Conducted for: South Carolina Department of Transportation

Subject: I-73 South Section Right of Way Plans

Over a two-day period, March 10-11, 2009, the Value Engineering Study Team reviewed the Right of Way Plans for the southern section of the proposed, new Interstate 73. The study began with an overview of the project and presentations from the design team.

Original Directional Interchange

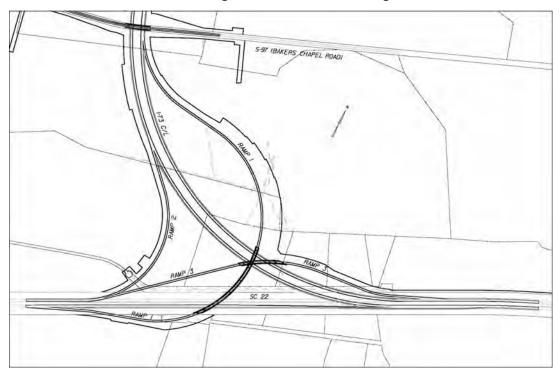
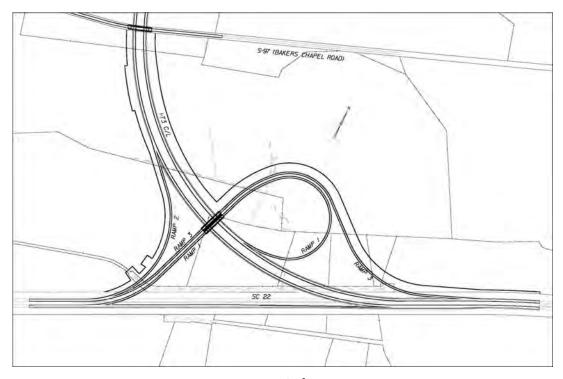
Revise current three-level, multiple structure interchange to a T-type, trumpet design.

I-73 adjoins SC22 just east of the SC22/SC319 interchange and will continue eastward towards Conway. The VE Study Team discussed the possibility of revising the I-73/SC22 Interchange to a one-lane or two-lane trumpet design instead of a system-to-system directional interchange. The design team was asked to provide cost estimates and schematic drawings of each option.

Reduce ramp fill heights and bridge requirements	Safety issues with loop design
for a cost savings estimated at \$31.1 Million	
Lessen length of Bakers Chapel Road crossing	Two of the four ramps will have reduced (60-40-60
bridge (end acceleration lane prior to crossing	mph) design speeds. Directional ramps are all at
under the Bakers Chapel Road bridge)	55 mph
No conflict with hurricane evacuation	May require reopening the EIS to assess impacts
Handle estimated volumes at design year (with	
projected SELL project volumes)

Bridge 7D Crossing at SC917 Reconfigure the bridge to reduce the heavy skew.

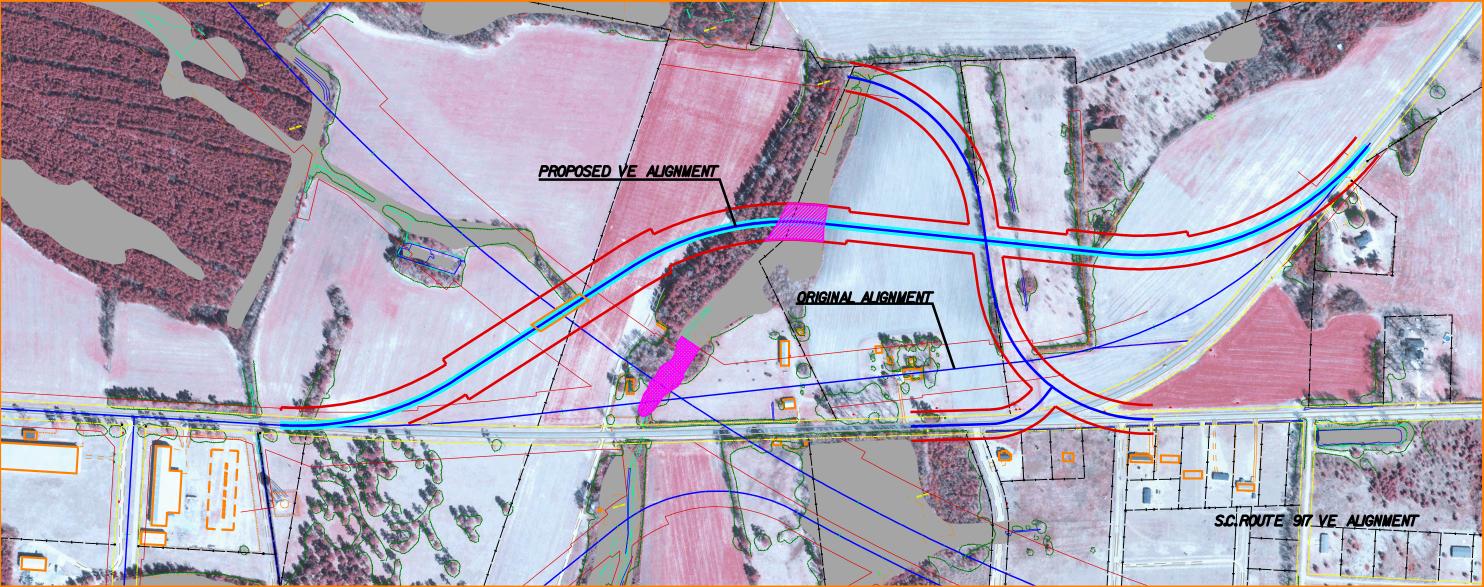
Cost savings of \$1.6 Million in bridge construction	Would require reopening the EIS document to
	assess the impacts
Avoid displacement	Less desirable roadway alignment
Significantly reduce skew	Multiple horizontal curves introduced on SC197
Concrete girders require less maintenance than	Anything changed at this point will be
steel girders	controversial with the community
More predictable seismic behavior	Increased wetland impact of 0.7 acres.

Bridge 14D Crossing at S198 Reconfigure the bridge to reduce the heavy skew.

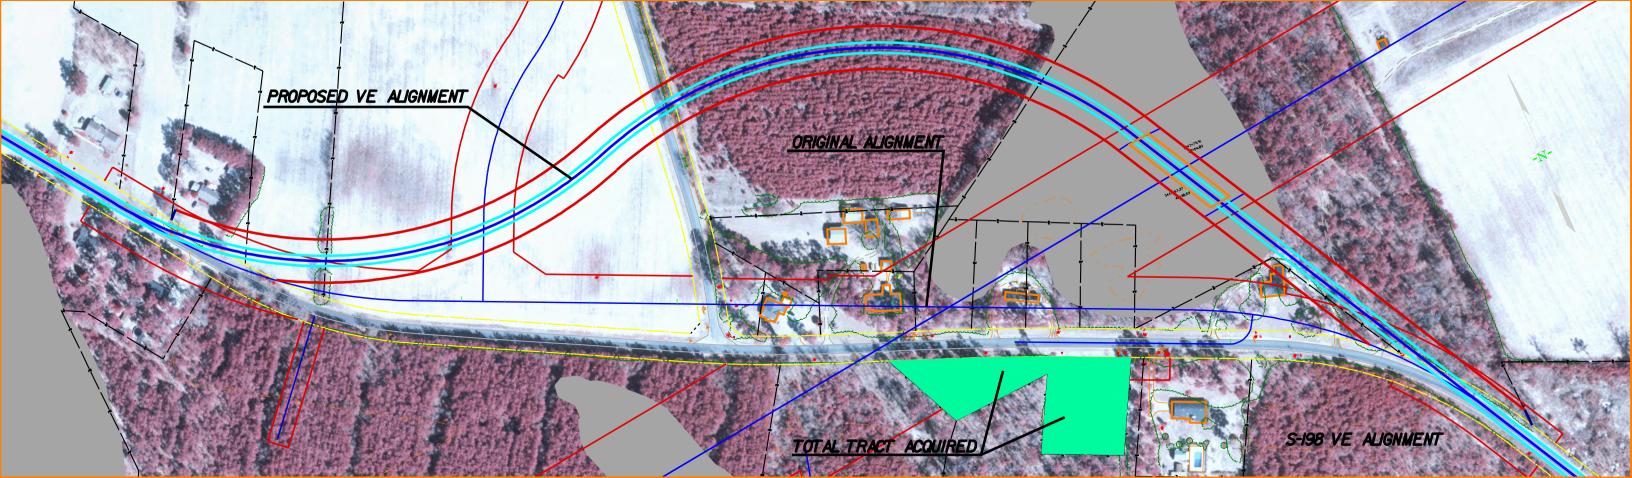
Cost savings of \$2.3 Million in bridge construction	Would require reopening the EIS document to
	assess the impacts
Eliminate need for run-around	Additional wetlands impact (.8 acres)
Skew improved	Some total-take tracts have already been acquired
	by SCDOT
Concrete girders require less maintenance than	
steel girders	
More predictable seismic behavior

Bridge 15D Crossing at S27 Reconfigure the bridge to reduce the heavy skew.

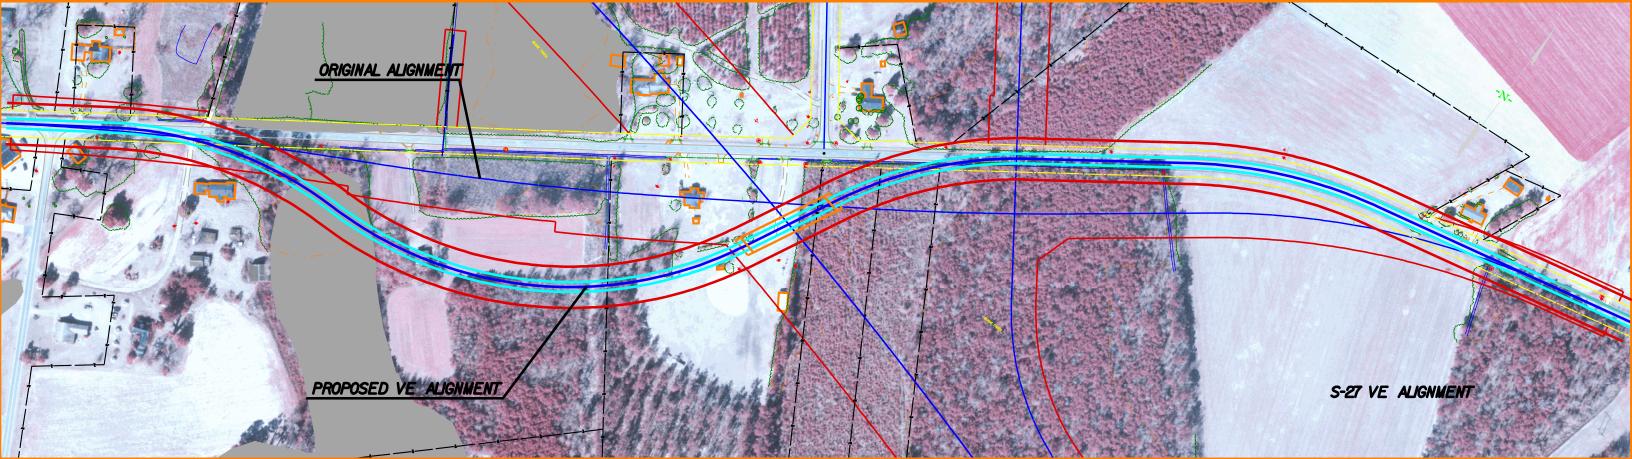
Cost savings of \$1.3 Million in bridge construction	Would require reopening the EIS document to
	assess the impacts
Skew improved	Additional wetlands impact (.3 acres)
Concrete girders require less maintenance than	Less desirable horizontal alignment for S27
steel girders	
More predictable seismic behavior	May cause additional displacement (structures on
	Tract 150)

Bridge 56D Crossing at \$309 Reconfigure the bridge to reduce the heavy skew.

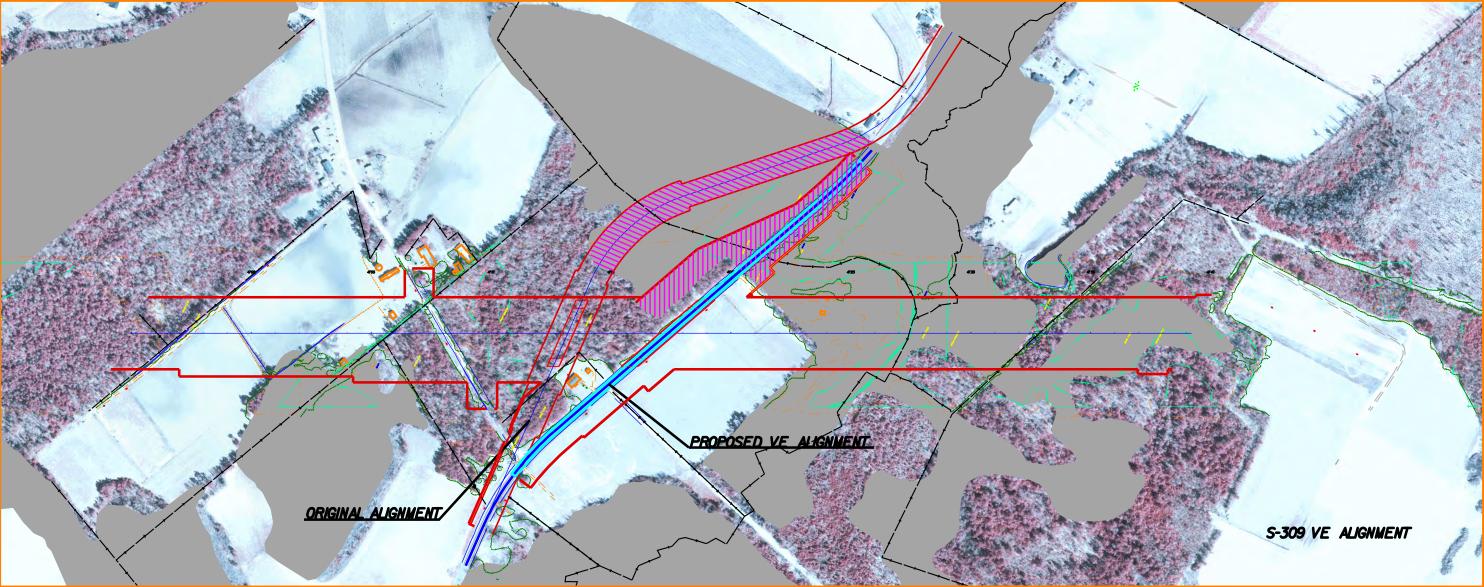
Cost savings of \$1.1 Million in bridge construction	Would require reopening the EIS document to
	assess the impacts
Skew improved	Additional wetlands impact of 3.2 acres
Concrete girders require less maintenance than	
steel girders	
More predictable seismic behavior

Justification for the S308 Interchange

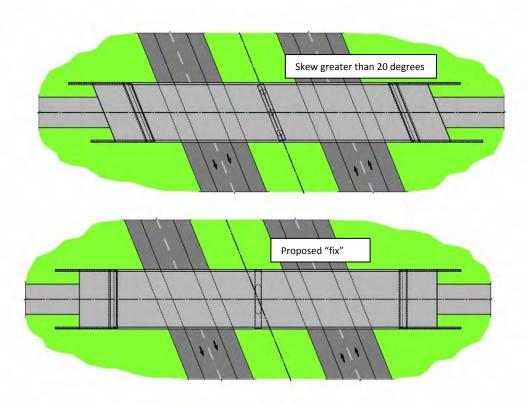
The VE Study asked the design team to provide justification for the S308 interchange and for the location chosen for that interchange. Here are their responses:

- Without the S308 interchange, there was no access between US 701 and US 76 interchange, a distance of over 25 miles.
- Other potential locations are at S23 (South Nichols Highway) or S99 (Lake Swamp Road).
 The communities at S23 and S99 did not want the interchange at those locations, fearing an interchange would alter the character of the community.
- There would be additional relocation impacts at either S23 or S99.
- Ketchup Town, located on S99, is considered to be a local landmark and would be impacted significantly by the interchange.
- Horry County requested the S308 location for the interchange to provide more direct access to the Cool Springs Industrial Park.

Figure 1: Proposed I-95/I-73 Interchange Layout

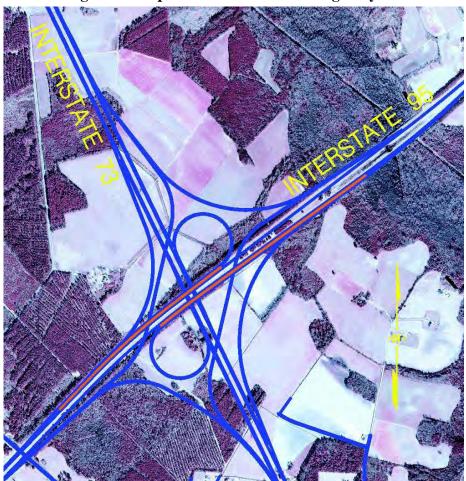
We have completed the design year (year 2035) capacity analysis of the two flyover ramps (I-95 northbound to I-73 northbound and I-95 southbound to I-73 southbound) at the proposed I-73 interchange with I-95. The primary intent of this analysis is to determine whether or not the single lane concept on the flyover ramps would provide an acceptable operating condition. The proposed interchange layout is shown in **Figure 1**.

Figure 7: SimTraffic Snapshot of Two Lane Flyover Concept 1-95N to 1-73N 1-95S to 1-73N No congestion on two lane flyover ramps

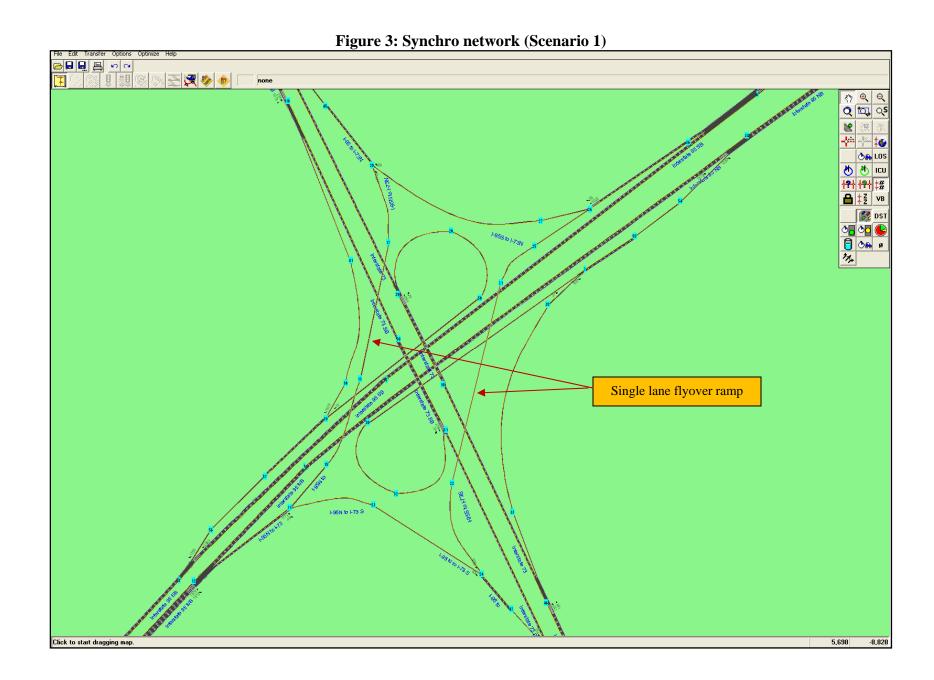
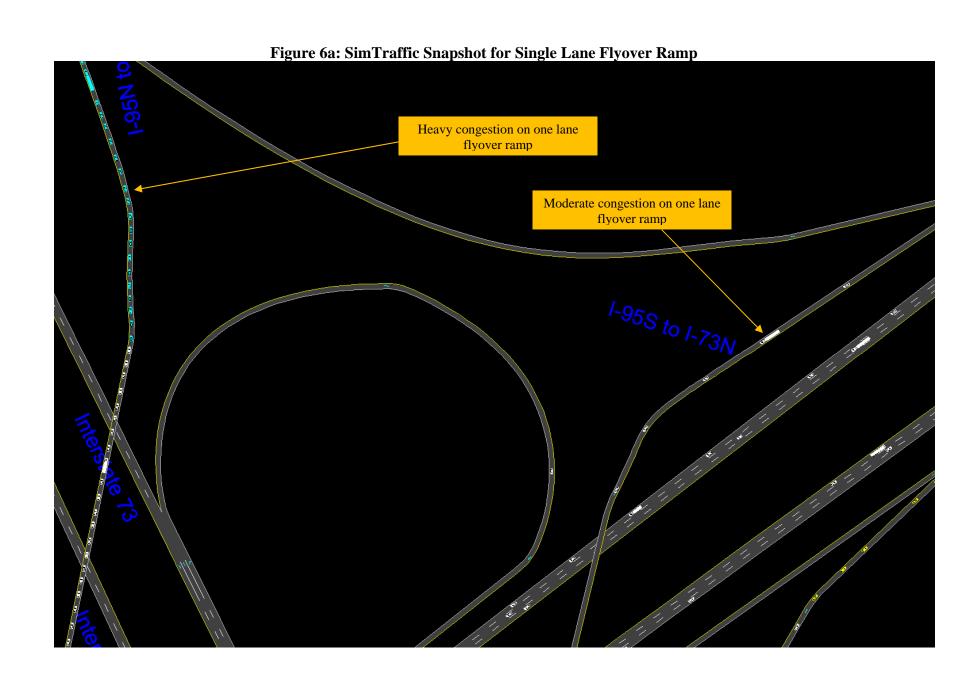
The snapshots of the SimTraffic animation program for the single lane and two lane flyover concepts are shown in **Figure 6** and **Figure 7** respectively. The snapshots were captured after a complete one hour simulation run.

The snapshot shows that a heavy congestion on I-95 northbound to I-73 northbound ramp for the single lane flyover. The congestion problem is reduced significantly with the two lane flyover ramp concept.

- Both flyover ramps may be designed as a two-lane facility in order to avoid any lane closure possibilities during any accident or crash occurrence on the ramps;

- I-95 northbound to I-73 northbound will operate at 80% of the capacity in the design year 2035. At an annual average traffic growth rate of 1.24% the projected traffic volume on the ramp will exceed the capacity in the year 2053 (18 years beyond the design year).

- Although I-95 southbound to I-73 southbound flyover ramp operates at an acceptable LOS for both single and dual lane concepts, but it is recommended that the ramp should be designed as a two-lane facility in order to maintain the interchange symmetric.
